LiDAR Quality Assurance (QA) Report  
Coastal New York LiDAR  
NOAA Coastal Services Center  
NOAA Contract: EA133C-11-CQ-0007  
October 4, 2012

<b><u>Contract:</u></b> Coastal New York LiDAR	<b><u>Production Contractor:</u></b> Photo Science, Inc.	<b><u>Date Prepared:</u></b> 10/4/2012	<b><u>Delivery #:</u></b> Area 2, Delivery 2	<b><u>Dewberry Recommendation:</u></b> Accept all Data for Priority Area 2 (Long Island)
<b><u>Data History:</u></b> □ Area 2, Delivery 2

The following LiDAR quality assurance report documents Dewberry's secondary review of LiDAR data and derived products for the Priority Area 2 of the Coastal New York LiDAR Project by Photo Science, Inc. (PSI) for the NOAA Coastal Services Center. Priority Area 2 consists of approximately 847 square miles that amount to 1,338 LAS tiles (1500 meters x 1500 meters) and 433 hydro enforced DEMs (3000 meters x 3000 meters). Each tile contains LAS point cloud data classified according to the ASPRS classification scheme. The deliverables also include an ESRI Geodatabase containing hydrographic breaklines.

Figure 3 - A feature class of the LAS files' extent created from the header information. Tile 18TXK105955 from the first delivery does not have the correct extent.

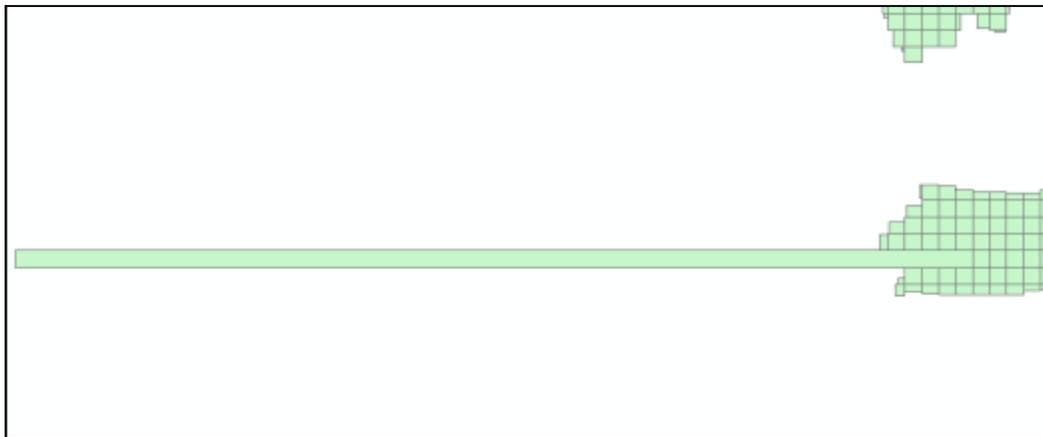
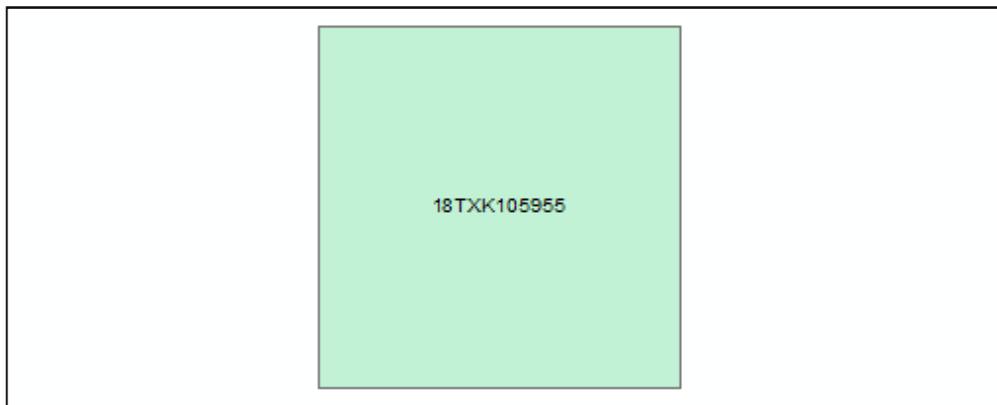
The header for tile 18TXK105955 originally contained an incorrect value for in the X Min field. The header for this tile has been reprocessed and is now correct.

Figure 4 - A feature class of the LAS files' extent created from the header information. The extent of tile 18TXK105955 has been corrected in the second delivery.

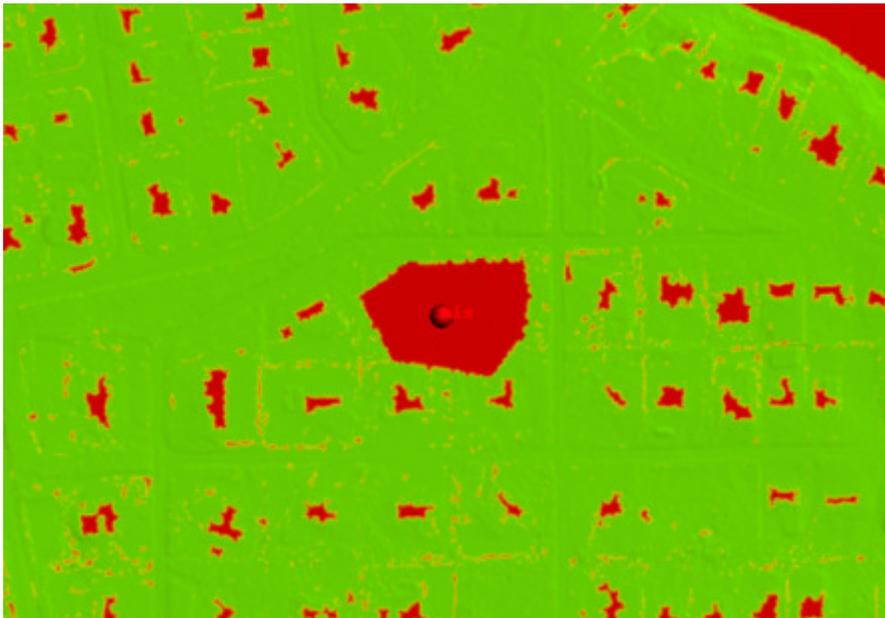
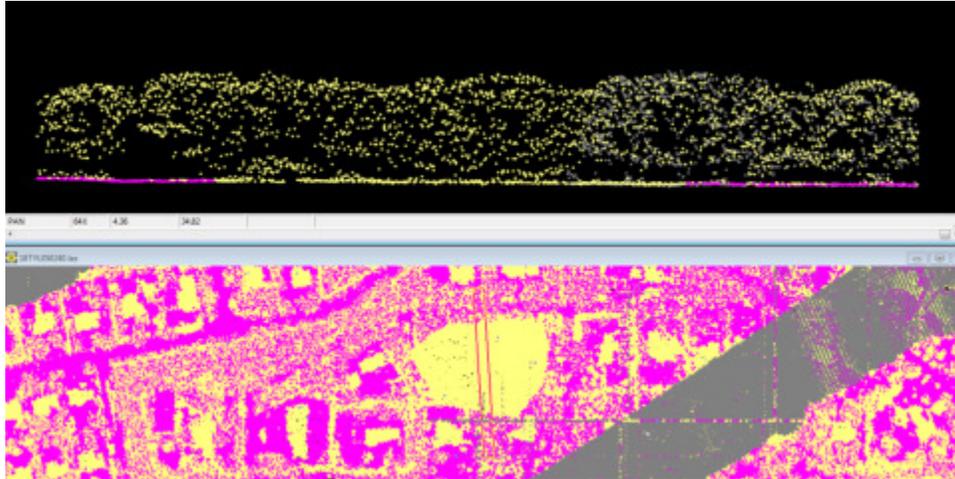
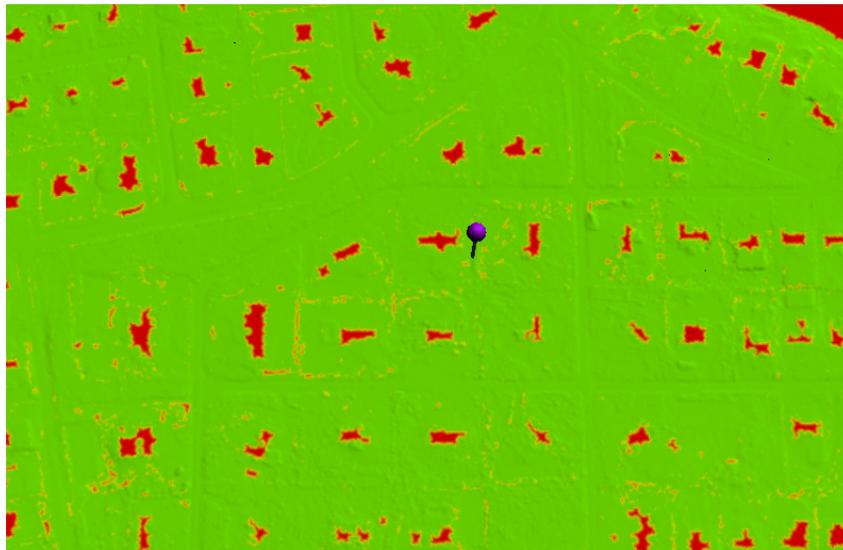
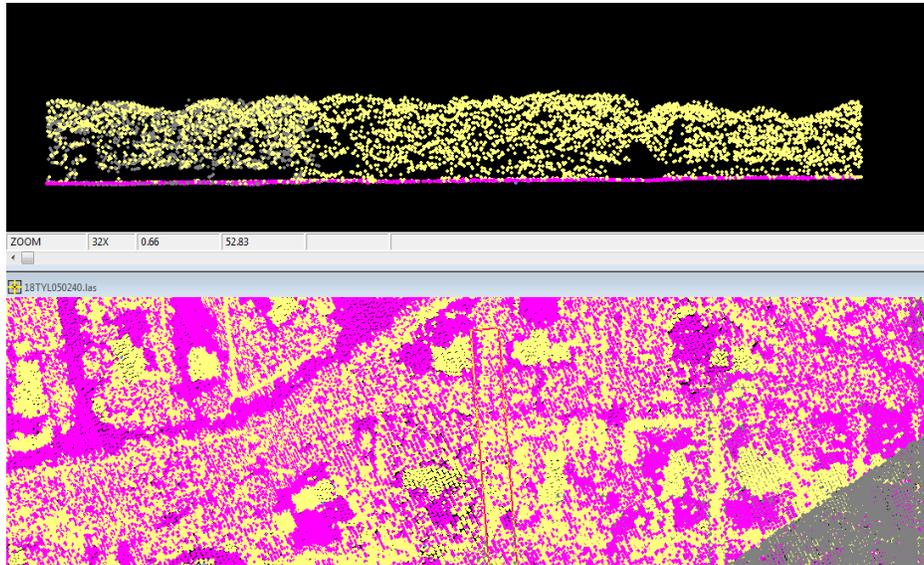
Figure 7 - Tile 18TYL050240 from the first delivery. Profile view of LAS cloud colored by classification is shown on top while LAS colored by classification is shown on bottom. This image shows that there are legitimate class 1 (yellow) points that could be reclassified to class 2 (purple), in order to improve the definition of the bare-earth surface.

Figure 8 - Tile 18TYL050240 from the second delivery. Ground density model shows points have been added back to ground.

Figure 9 - Tile 18TYL050240 from the second delivery. Profile view of LAS cloud colored by classification is shown on top while LAS colored by classification is shown on bottom. Class 1 (yellow) points have been reclassified to class 2 (purple) in order to improve the definition of the bare-earth surface.

Figure 10 - Tile 18TXL480075 from the first delivery. LAS point cloud colored by classification. The island feature can be identified as incorrectly classified as tidal water (gray) and should be reclassified as ground (purple).

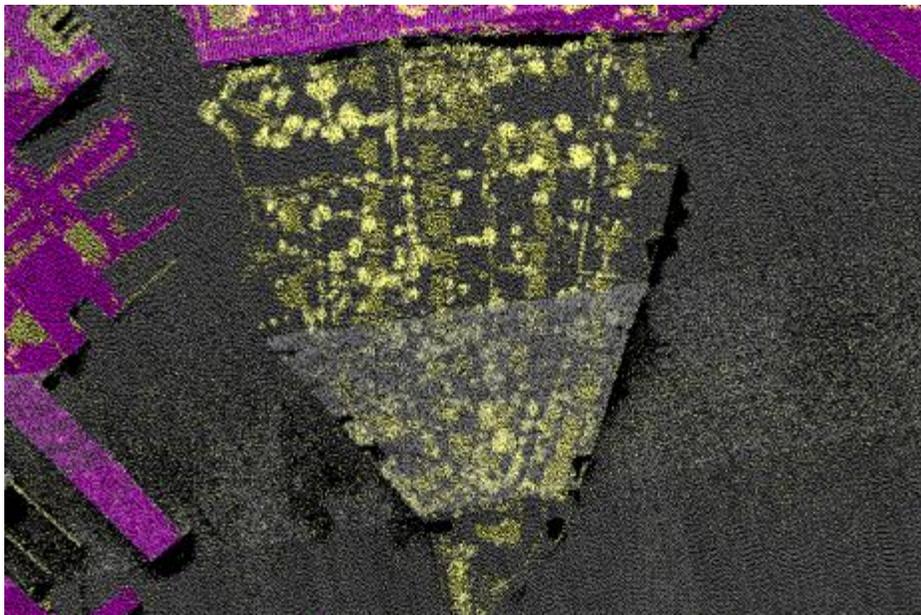
Delivery 1 contained 9 instances of misclassification where islands were incorrectly classified as water. These islands were removed from the breaklines but were not classified to ground. In order to preserve the accuracy of the ground model, these land masses needed to be changed from class 14 to class 2 (ground). All 9 instances of this type of misclassification have been corrected in the second delivery. An example of this type of misclassification, along with the correction, is shown below.

Figure 12 - Tile 18TXL480075 from the second delivery. LAS point cloud colored by classification. Tidal water (gray) has been reclassified as ground (purple) to properly show island features.

Figure 13 - Tile 18TXL105195 from the first delivery. Ground density model showing a structure that was left in the ground.

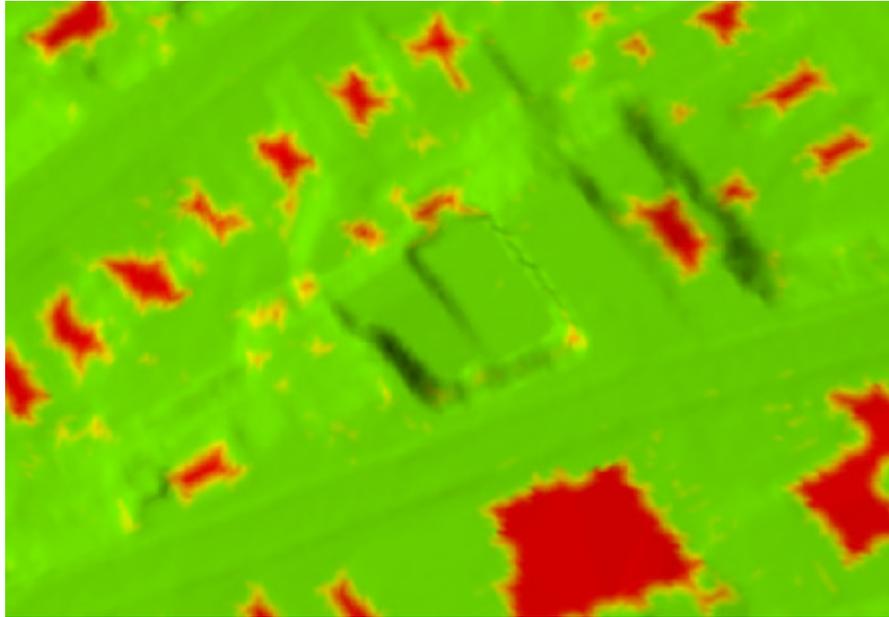
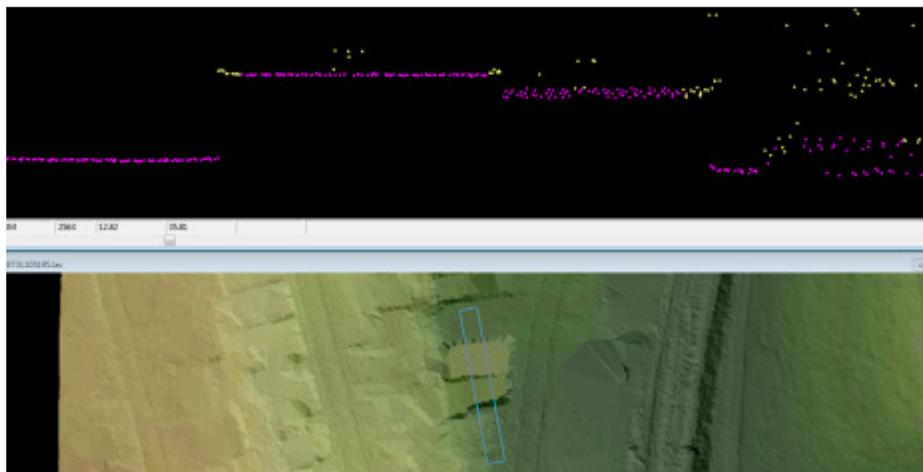
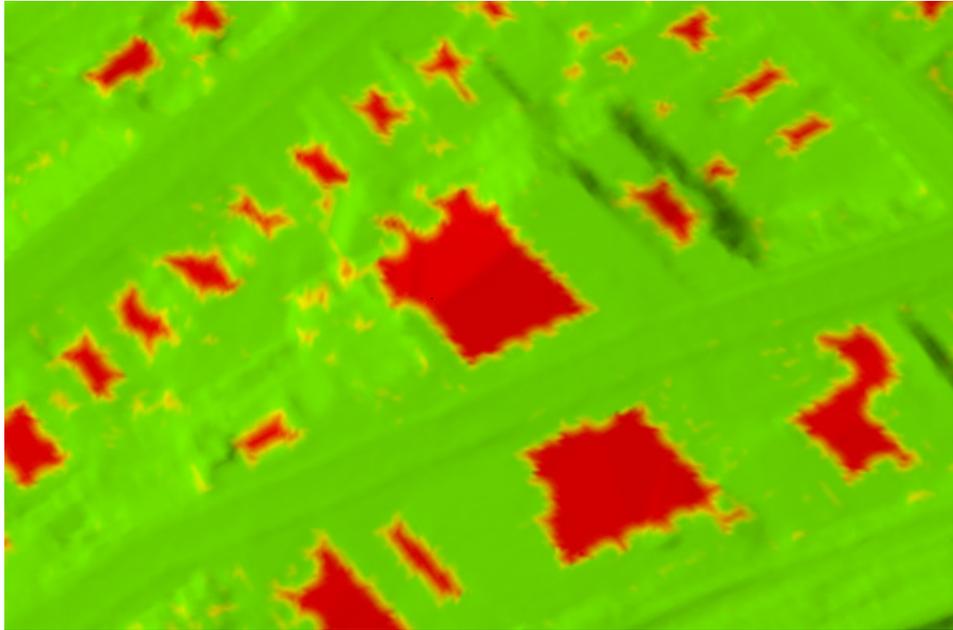
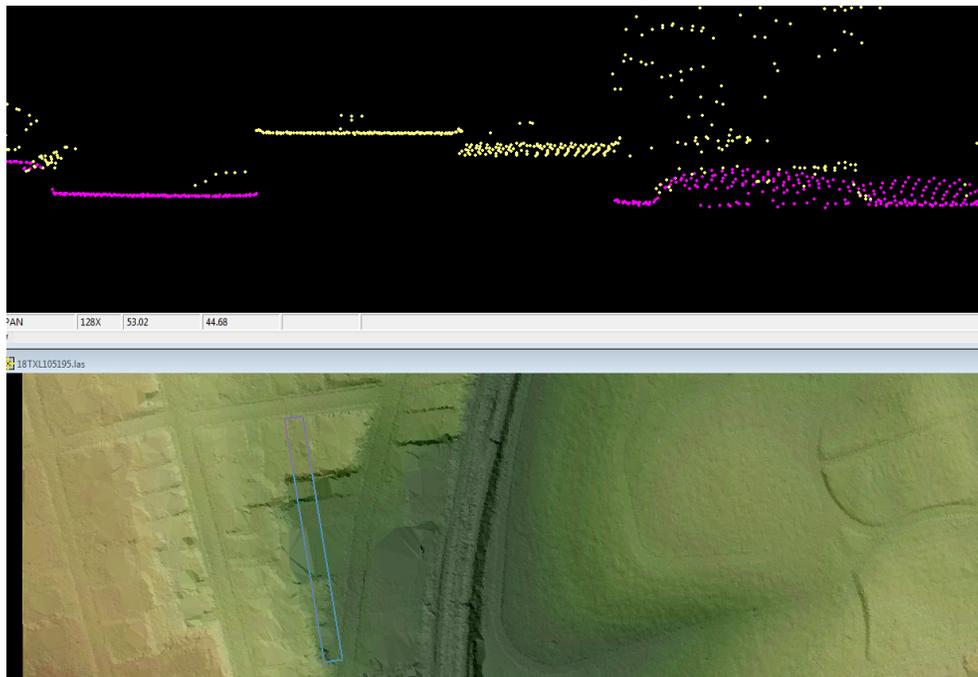
Figure 14 - Tile 18TXL105195 from the first delivery. Profile view of the LAS cloud colored by classification is shown on top while bare-earth TIN colored by elevation is shown on bottom. The structure can be seen next to the hillside and should be reclassified to unclassified (class 1).

Figure 15 - Tile 18TXL105195 from the second delivery. Ground density model showing structure was removed.

Figure 16 - Tile 18TXL105195 from the second delivery. Profile view of the LAS cloud colored by classification is shown on top while bare-earth TIN colored by elevation is shown on bottom. The structure has been removed.

Figure 17- Tile 18TXL045165 from the first delivery. Full point cloud intensity image overlaid with a stream breakline (red) 1 meter in length. This feature should be removed from the breaklines.

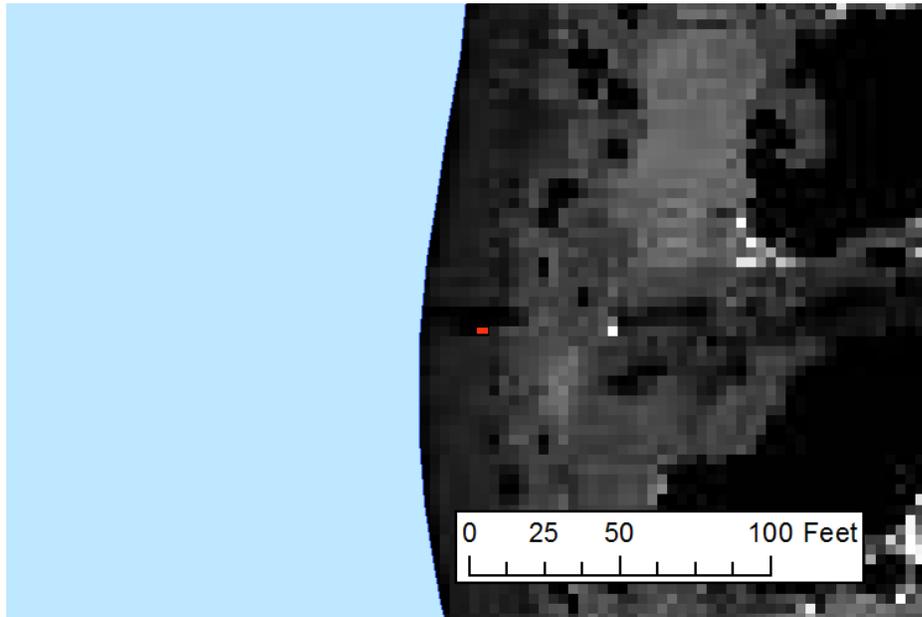
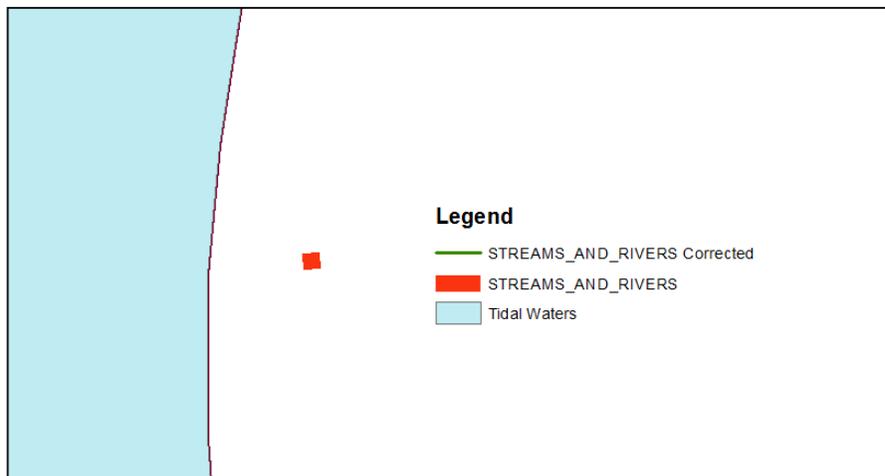
One (1) issue was previously identified for a small stream breakline that did not collect any legitimate water or meet any topological requirements. This breakline was removed from the dataset. An example of the issue, along with the correction, is shown below.

Figure 4- Tile 18TXL045165 from the second delivery. Stream breakline (red) 1 meter in length has been removed from the new stream breakline data (green).

Figure 20 – DEM tiles 18TXL780090 and 18TXL780120 from the second delivery showing coastal water breakline (blue) has been adjusted to capture all of the water in the area.

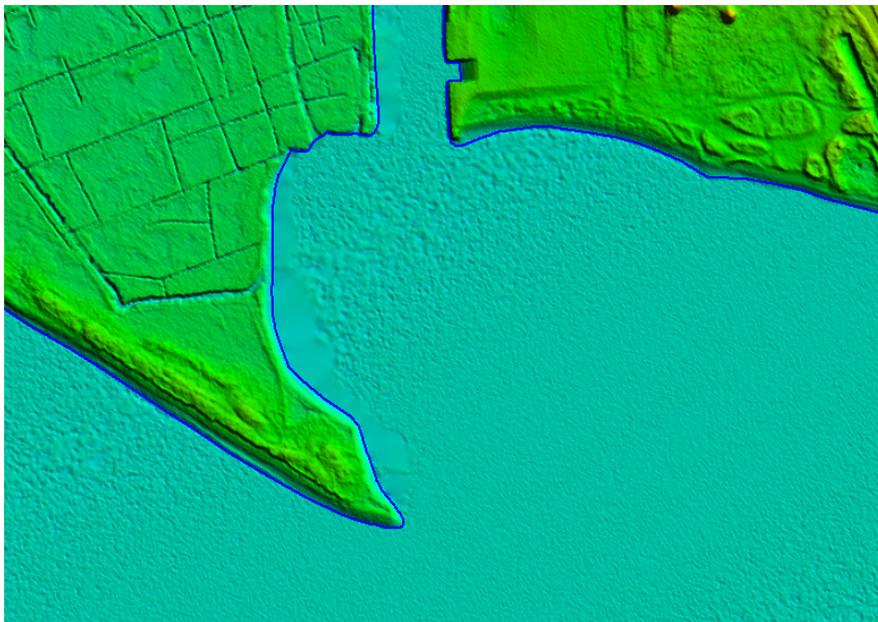
Figure 19 - Tiles 18TXL780105 and 18TXL780120 from the first delivery. Coastal water breakline (blue) is overlaid on the full point cloud intensity imagery. The breakline should be adjusted to capture all of the water in the area.
